MEMORANDUM

TO: Cassie Younger, Maverik, Inc.
FROM: Stacey Nerger, Senior Planner
DATE: November 23, 2022
SUBJECT: SP21-133 Lincoln Professional Park Filing No. 1 Lot 1 Site Plan

LINCOLN PROFESSIONAL PARK FILING NO. 1 LOT 1 MAVERIK INC. STORE SITE PLAN

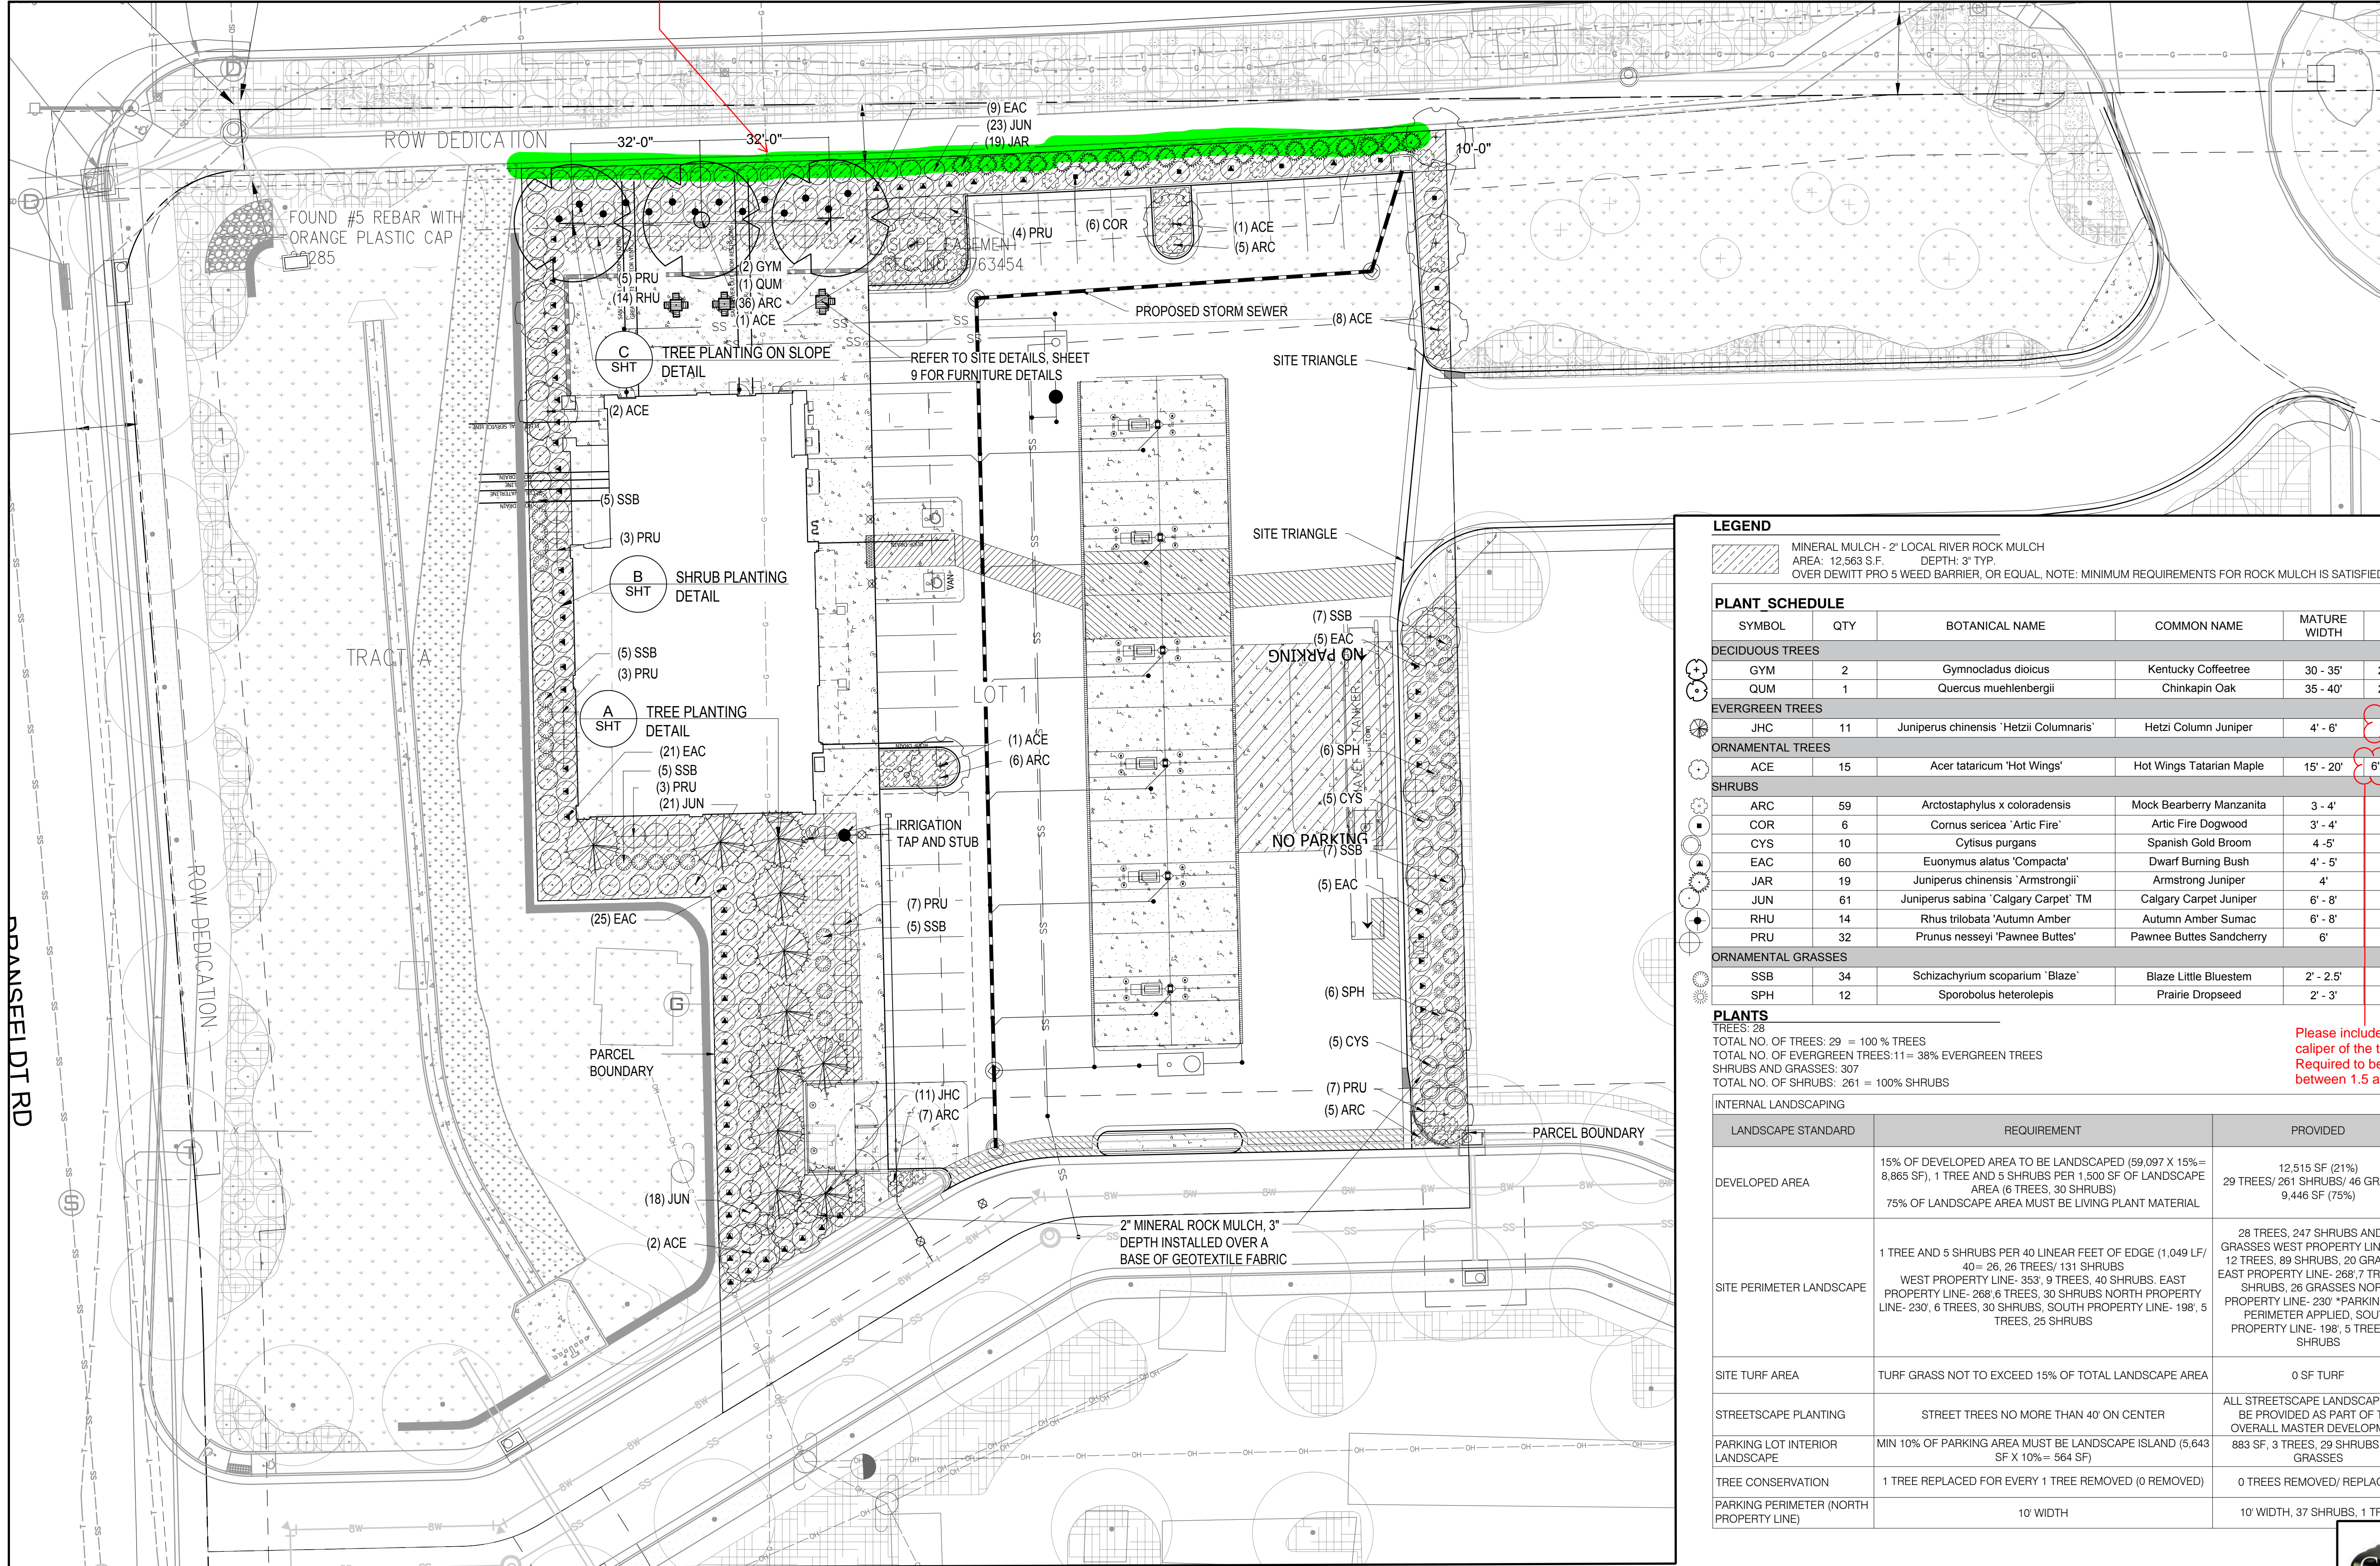
Not sure if this is correct, but there looks to be a small gap in the landscaping between the back of curb and the shrub beds starting. Please ensure this landscaping is carried all the way to the sidewalk.

LANDSCAPE PLAN

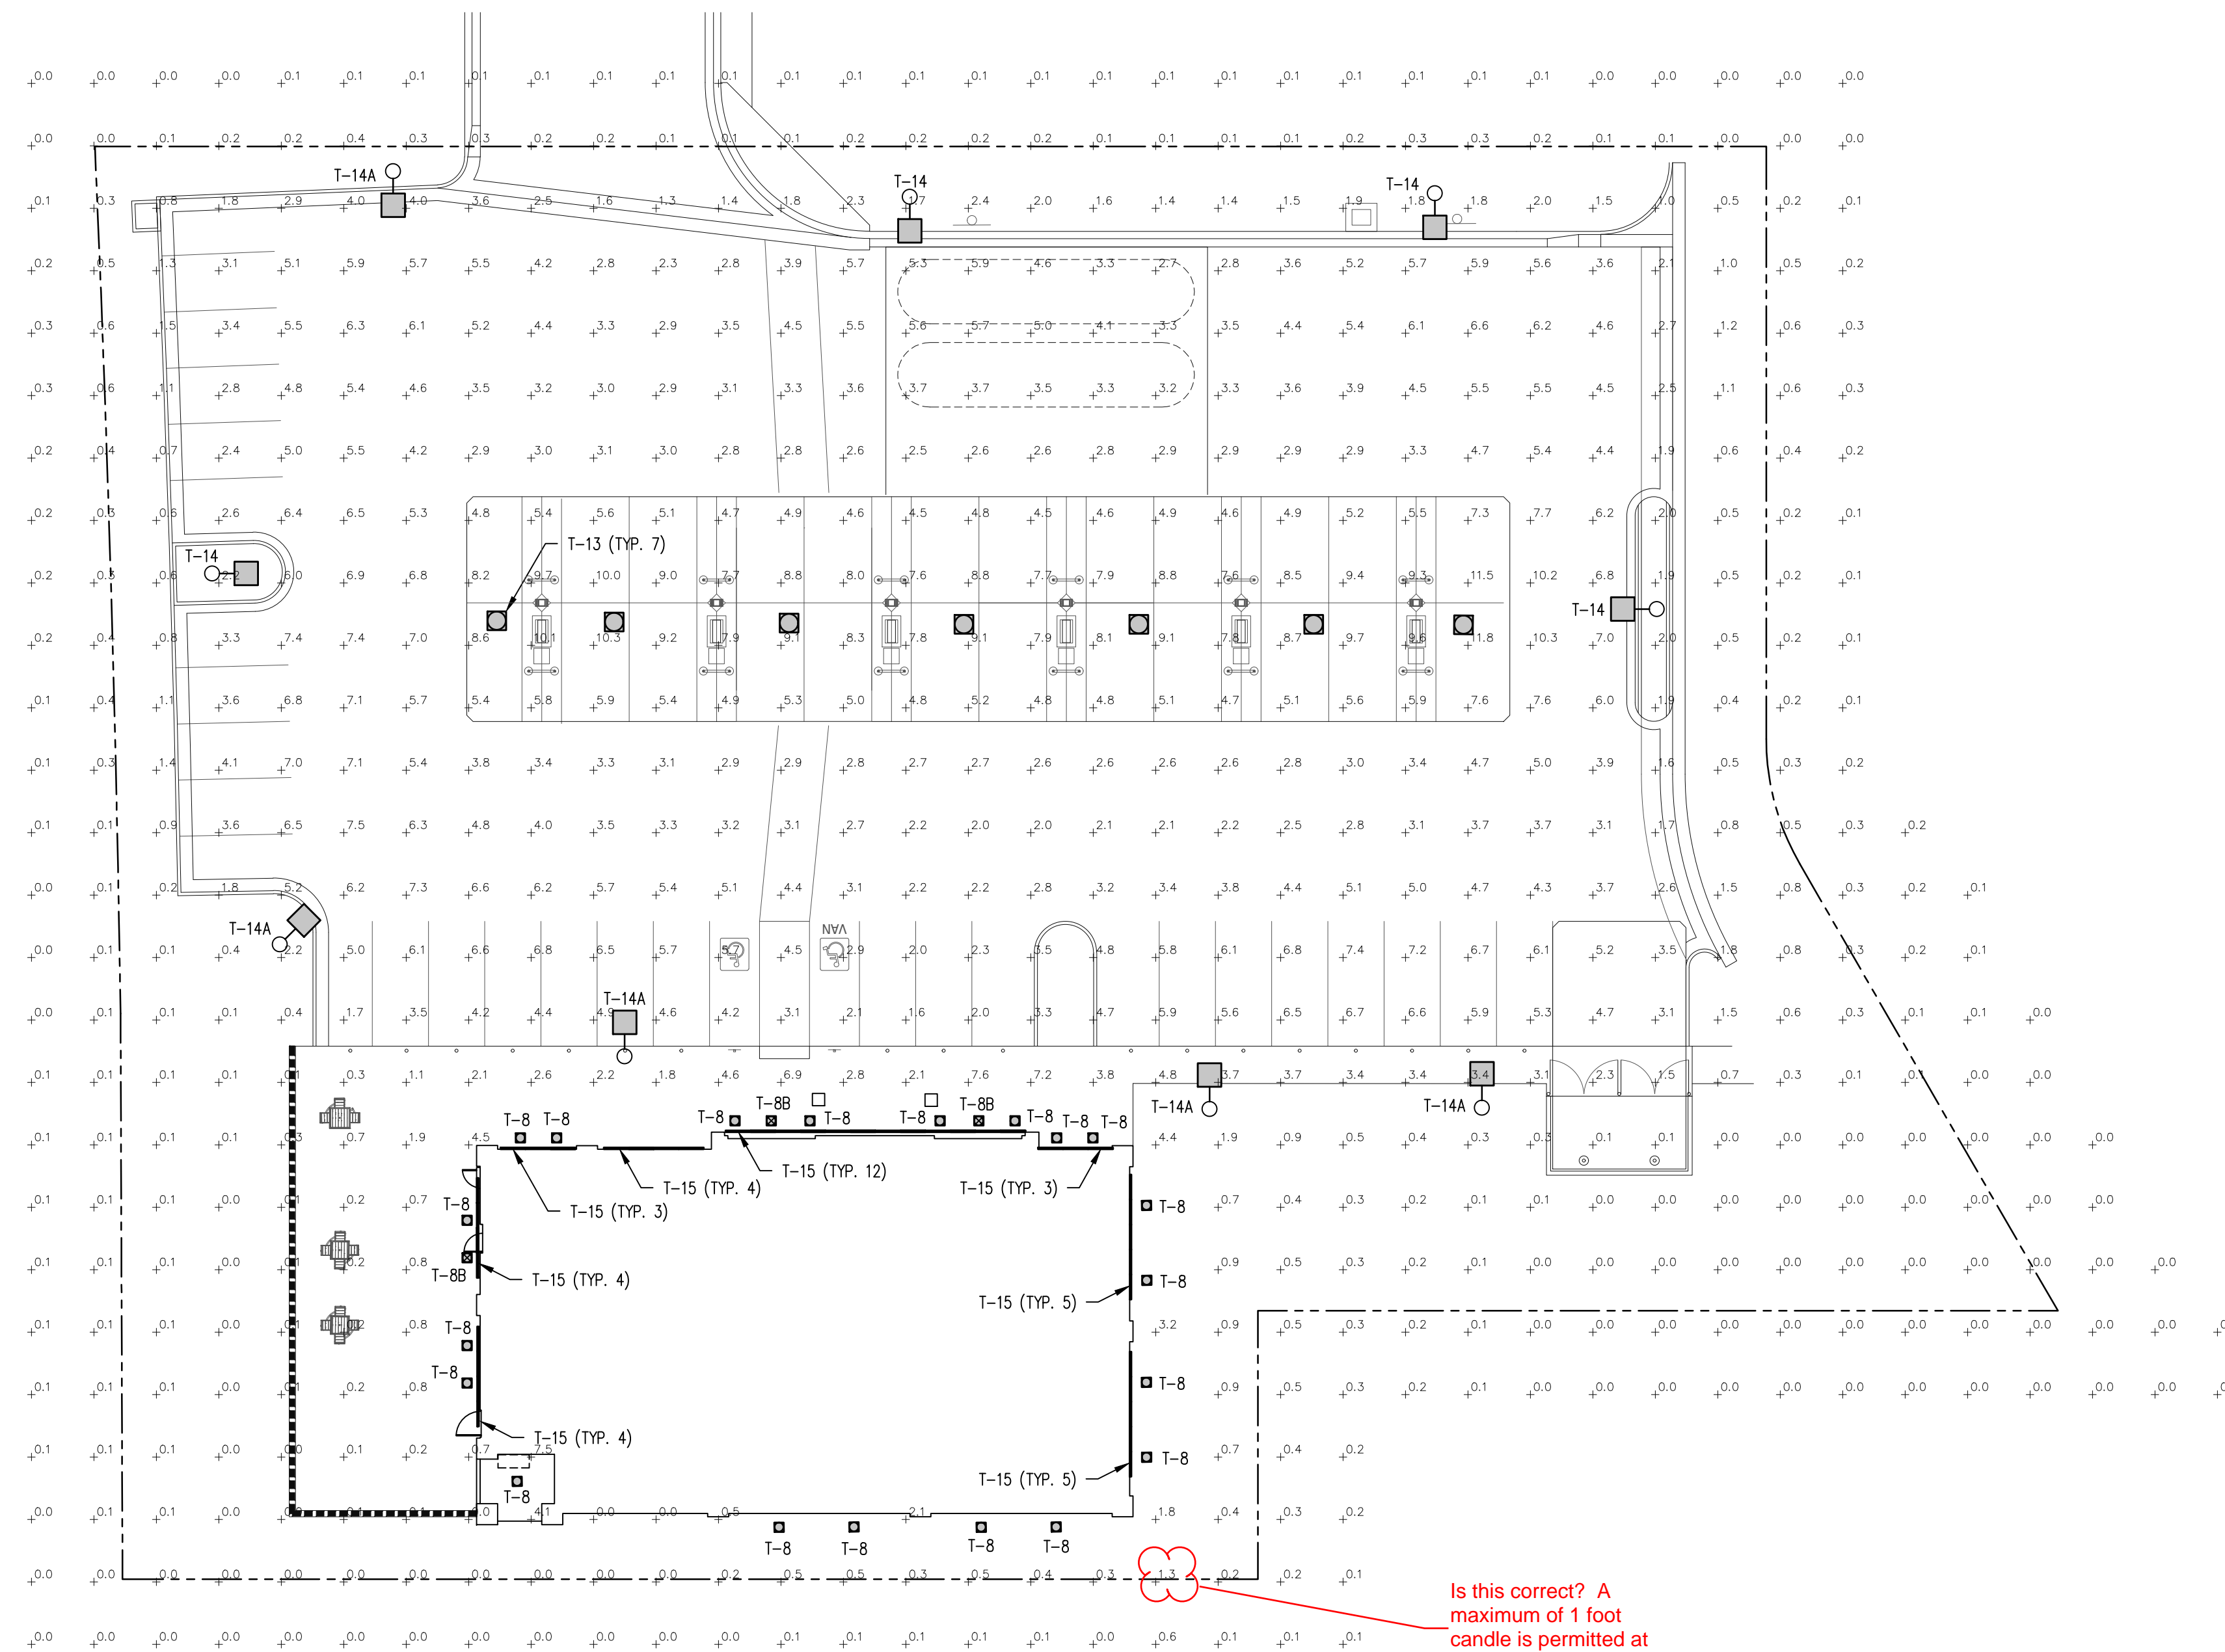
Is this correct? This should be between 6-8 feet.

Please include the caliper of the trees. Required to be between 1.5 and 2".
